City of Bentonville, Arkansas
Bentonville WRRF Improvements

Reference is made to your Submittal 15500-04F Makeup Air Units A01-A03 dated August 14, 2026. The following data pertains to Section(s) 15500 of the Specifications.

Title
15500 - Heating, Ventilating, and Air Conditioning : Product Information : Make-Up Air Unit 03 - 05

Submittal	
LOCATION	Bentonville, AR
DATE	August 12, 2026
PRODUCTS	Review Letter - Other Air Handling Unit - MAU-A01 - Bessamaire Air Handling Unit - MAU-A02 - Bessamaire Air Handling Unit - MAU-A03 - Bessamaire

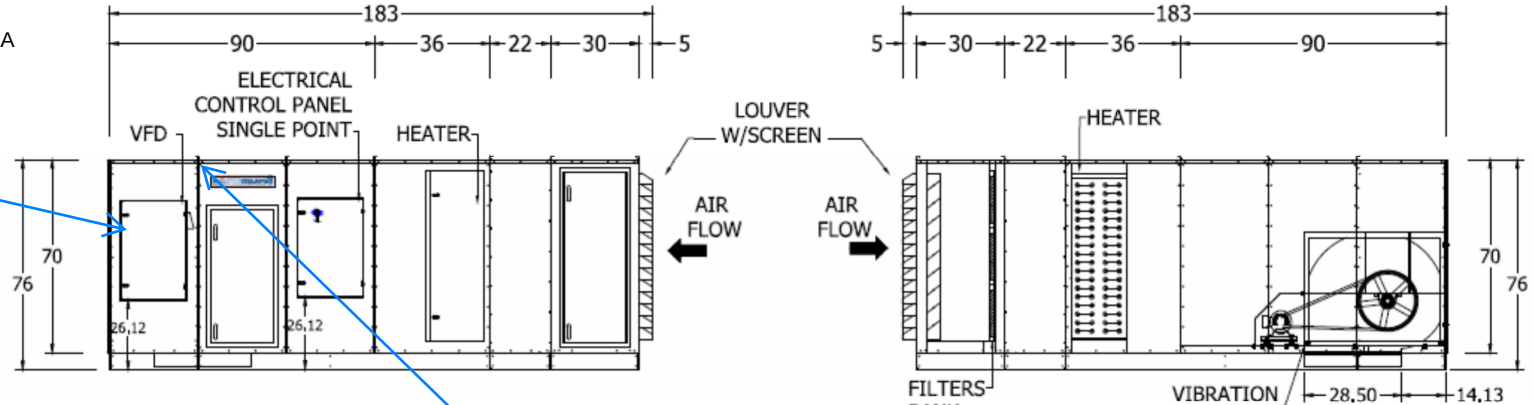
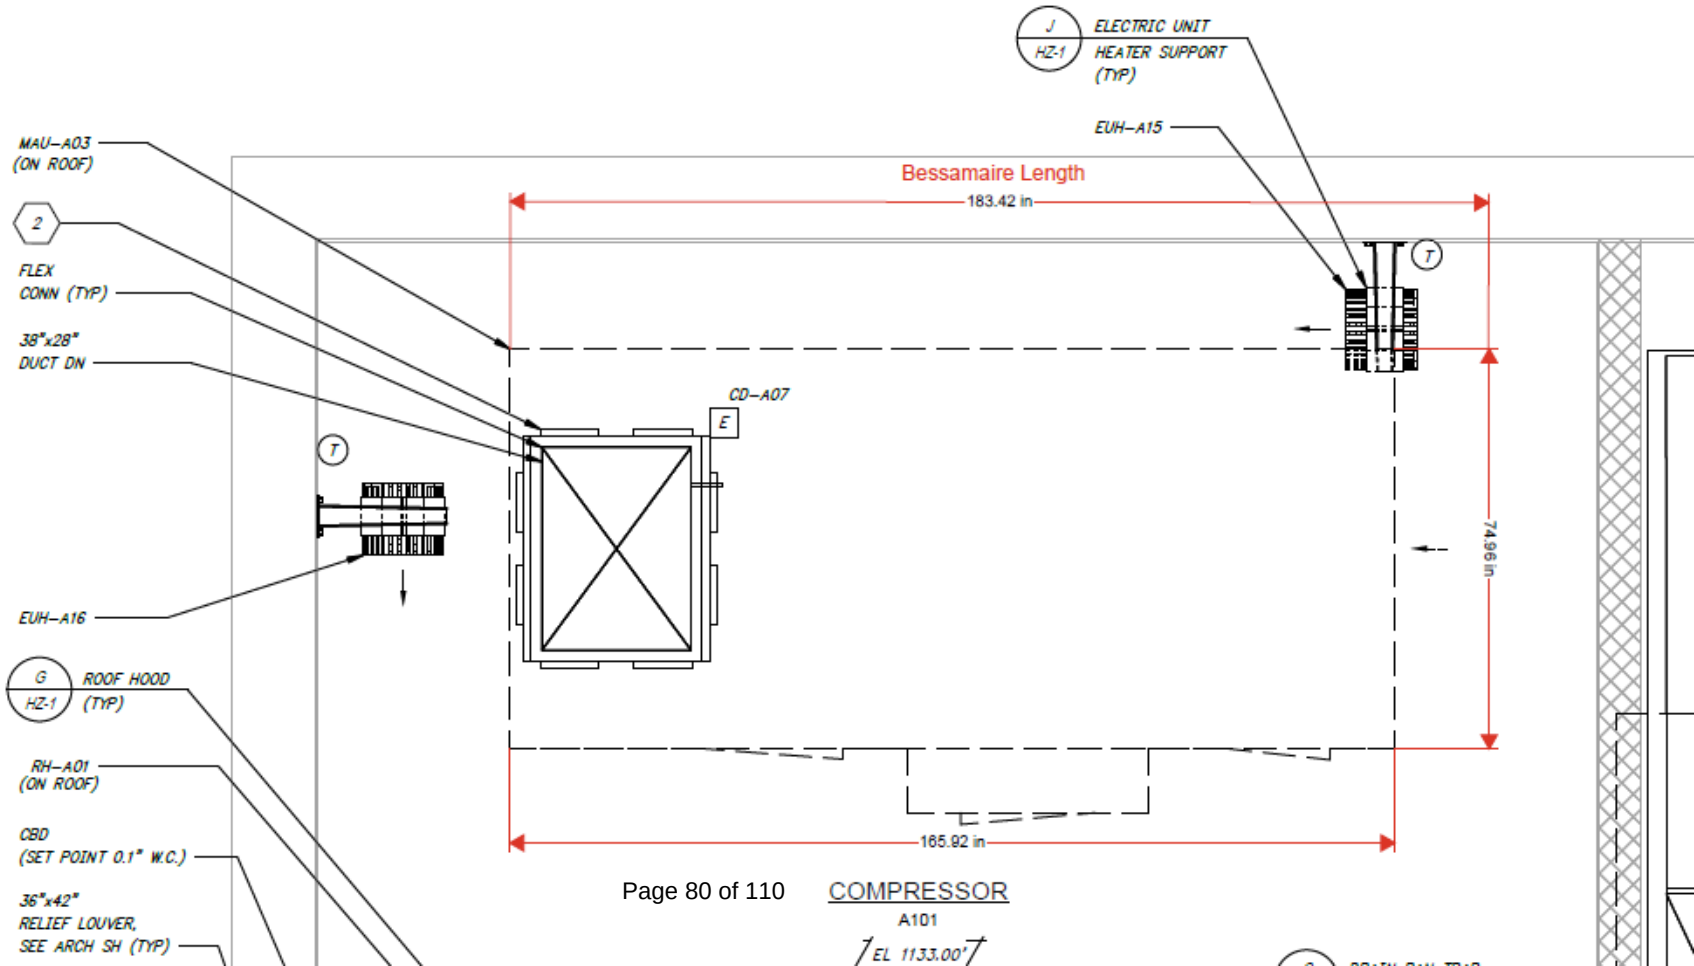
8/13/2026 resubmittal for record.
MAU-A03 - See added note: VFD cabinet is sealed from process air stream
MAU-A03 - See added note: service clearances

4. HVAC: Disconnects noted. Confirm with Electrical Code and Owner if disconnect needs to be lockable type.
5. HVAC: NEMA 4X VFD enclosures are noted as ventilated. Confirm VFD electronic internals have conformal coating or are isolated from the ventilation air. **See added note: VFD cabinet is sealed from process air stream**

Access Side Service clearance 36"

VFD CABINET IS SEALED FROM THE PROCESS AIR STREAM; VENTILATIED FROM FRESH OSA

SERVICE ACCESS: blower & heater service access for future change out VIA ROOF PANEL REMOVAL [roof panels are manufactured for removal]
